# Illustrated Parts List - IPL Update

**H555**

## 1. Filter holder

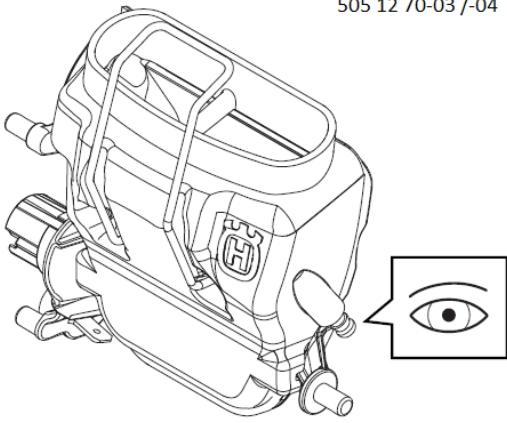
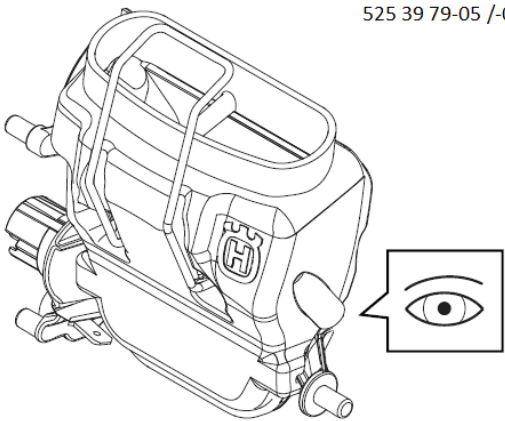
1. A new Filter holder, assy: 525 39 79-05 (standard) has been introduced. No nipple, hole removed to improve the startability.
2. A new Hose kit 589 35 71-01 replace the Hose 587 64 54-02. The new kit can be used for both new and old models regardless of which generation of filter holder the user have.
3. A new Hose 587 64 54-04 added for the new filter holders without nipple.
